Redrow Homes - Hesmond's Stud Detailed Planning Application WD/2022/0341/MAJ

Village Concerns Objection 9 - Biodiversity

Long Pond - Application Documents

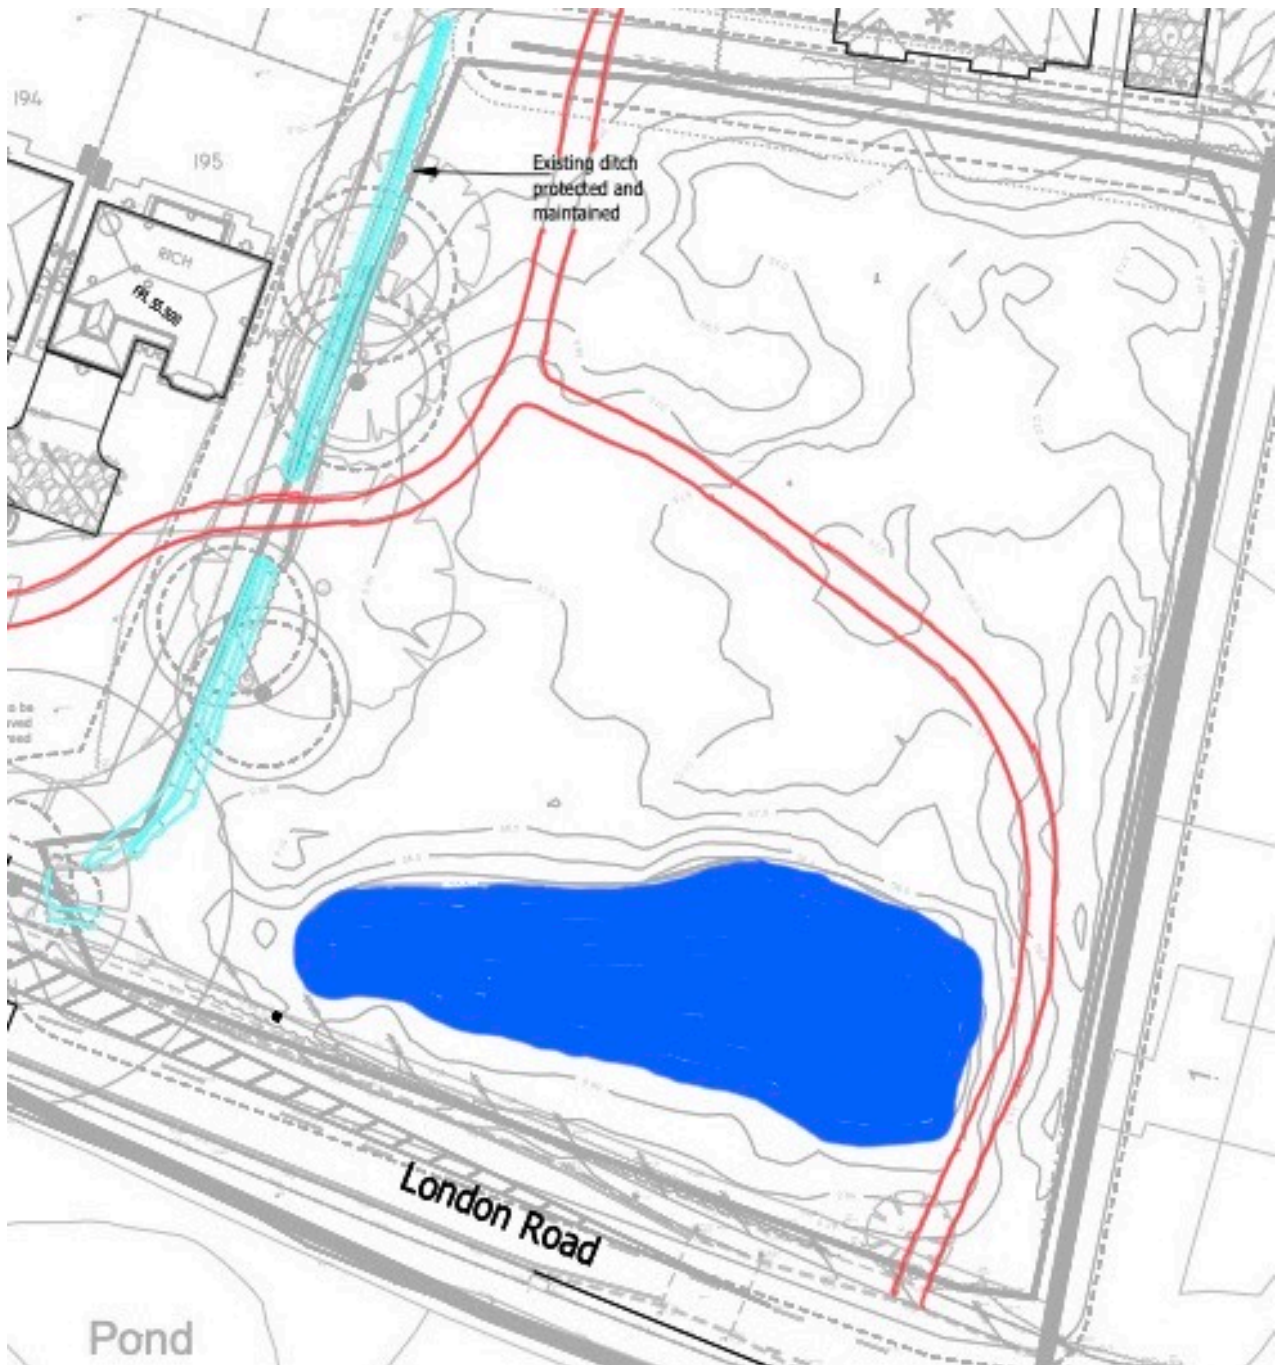
9. Long Pond is within the site boundary and is rich in biodiversity. It is therefore bizarre that Redrow barely mentioned it in their application documents submitted in January 2022.

10. The Design and Access Statement Issue 3 dated January 2022 did not show Long Pond on its Masterplan nor on most of the supporting documents. As a detailed planning application the future of such an important local feature and wildlife site should have had a detailed plan for its future. Several of their drawings showed paths over the location of the pond. One showed a path around the outside of the pond between the pond and the rear gardens of Thomas Turner Drive. Even a cursory examination of a map, let alone a site visit or a reading of the planning history of the site, would show that this is impossible. It was quite clear that in January 2022, Redrow had no idea of what they proposed for Long Pond. This was unacceptable for a full planning application.

Figure 3

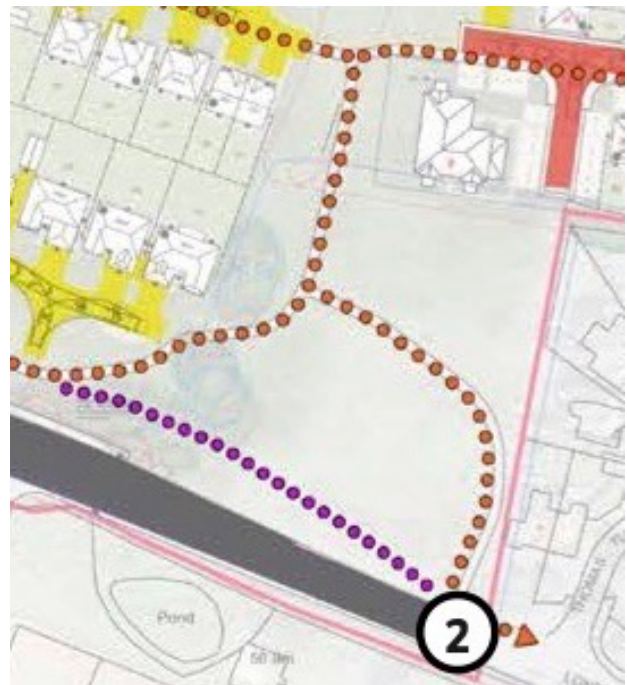
12. A new Design and Access Statement - Issue 4 has been added dated July 2022 which does not resolve the issue of what Redrow plan to do with Long Pond. In Issue 4 they show four different plans for Long Pond. Figure 1 is a Masterplan without any paths but does show the current size of the pond, Figure 2 is a plan showing a single path but the profile of the pond has been changed,

Figure 3 has no pond and an additional path round the very steep bank and finally, Figure 4 shows no pond and a path across the existing pond.

Figure 5

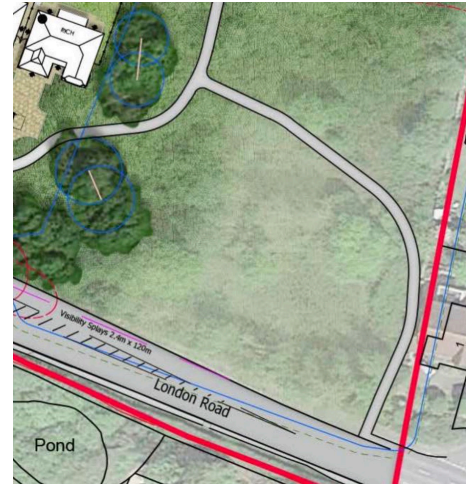
13. All of the drawings used in the Design and Access Statement Issue 4 dated July 2022 were out of date because Redrow added Planning Layout - Revision R dated 6 June 2022 (shown incorrectly on WDC website as 7 Jun 2022) and Revision S dated 13 June 2022. Revision R states “Proposed footpath connection to London Road moved to the east slightly to avoid conflict with existing pond” This small change to the footpath is shown in Figure 5 and it is clear that it has no significant impact on Long Pond, which again is not shown on the plan. The change in position of the footpath is irrelevant as it would still be positioned on a very steep and unstable bank. There could also be issues with placing it so close to residential housing. The problem with this is that it does not show the pond so is totally inadequate for a full planning application. It is also the same unworkable idea put forward in January 2022 (see Paragraph 11 above). This full planning application includes no definitive plan for Long Pond (including its associated ditch and area of scrub land). This failing flows through all the submitted documents. Nowhere is there a clear statement of what is proposed for the area of Long Pond. It needs a clear indication of what is proposed and only then can the impact on its biodiversity be determined. For example, if the path shown on the plans is constructed it is likely to require part of the Eastern end of the pond to be filled in. Would this mean it would be enlarged in another direction, if so, where ?

Protection of Existing Hedgerows and Trees

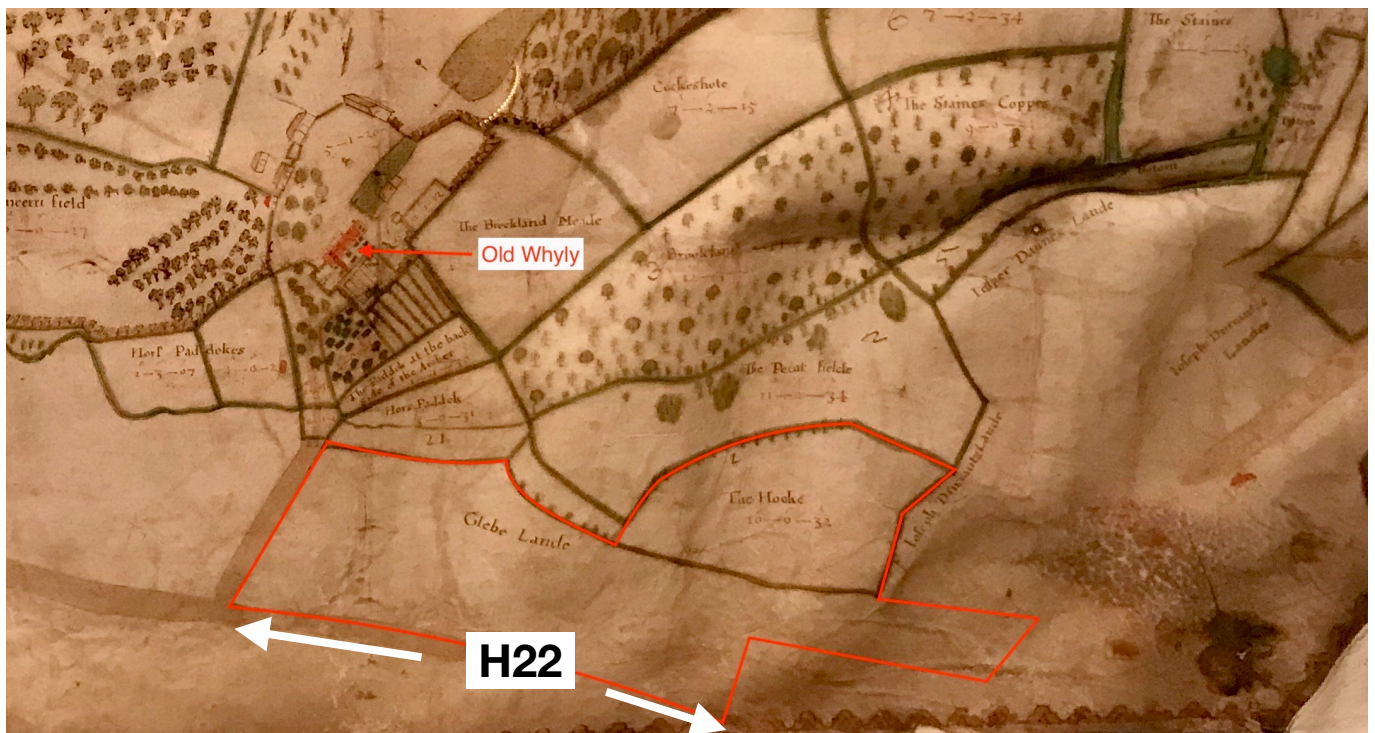
23. The Redrow Planning Application proposes to remove trees, hedgerows and habitats that are inconveniently placed for them to achieve their development plans. There is no need for this. A more environmentally sympathetic layout would retain all these havens of biodiversity and provide a more natural setting that does not resemble a housing estate. Redrow have imposed stock building designs in a standard housing estate layout that lacks any imagination to work with the existing nature. It may be that doing so might require them to build more smaller homes and less of the unwanted four and five bedroom homes but that is what a responsible developer would do in the setting of an historic rural village.

24. Hedgerow H13 appears from the drawings (Plan 5762 LLB DR Ab 0006 and 0007 Tree Protection Plan) to be proposed for removal by Redrow but it is shown in their Tree Removal Schedule as T13 (another piece of sloppy work in a rushed and incomplete full planning application). There is no need to remove hedges

H13, H16 or H32. The layout could be adjusted to accommodate these hedgerows retaining the majority of their habitats and providing access to each field through an opening in each hedgerow.
